RE: PZ# 24-12000027 Vera Site Plan ([494212000070](#))

The above-referenced Site Plan application has been reviewed by the Development Review Committee and discussed at the April 16th, 2025 DRC Meeting. Comments are being addressed and resolved with each discipline reviewer, though one outstanding comment is related to a necessary zoning code modification/waiver that would otherwise result in a development conflict with the City's CPTED guidelines as well as adjacent property conditions. We would like to take the opportunity to justify the need for Director modification/waiver in accordance with code sections 155.5203.F.2.e [Perimeter Buffers; Applicability].

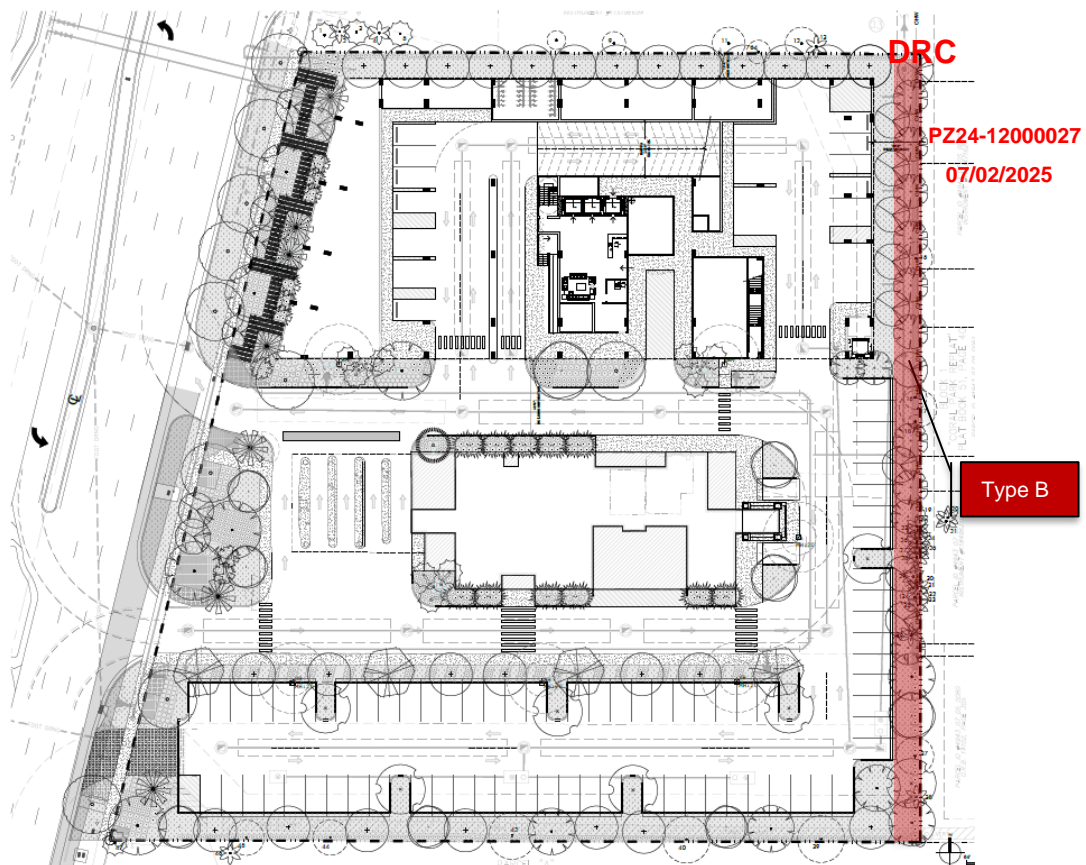
URBAN FORESTRY comment 7 states, "Please be aware that the required Type B buffer fence location as proposed will require a CPTED waiver signed by the DSD." **DRC**

As shown below, the property abuts multifamily residential zoning to the east where a Type B buffer is required per Table 155.5203.F.3. For the safety and privacy of the residential properties, we request all buffer landscaping to be installed inside of the wall, rather than placing the wall in the middle of the 10 foot-buffer. If a wall is placed in the middle of the buffer, maintenance of the landscaping and wall will be necessary, thereby possibly facilitating a maintenance worker to trespass onto residential private property. If the residential properties include a fence or wall on their private property, an additional wall will create an "alley" of unmaintained area that invites trespassing and possibly illegal activities. Providing the fence in the middle of the east buffer would put a maintenance worker near the railroad tracks which creates an unsafe condition for the maintenance worker.

As mentioned, requiring the buffer barriers in the middle of the 10-foot buffer not only violate the city's CPTED guidelines for Natural Surveillance but poses a safety risk for maintenance due to adjacent property conditions. Below is a summary of the buffer modifications/waivers we are requesting, with a diagram for these:

Buffer	Barrier Material	Barrier Location
East Type B	Solid fence, no waiver requested	Exterior boundary of buffer, rather than middle
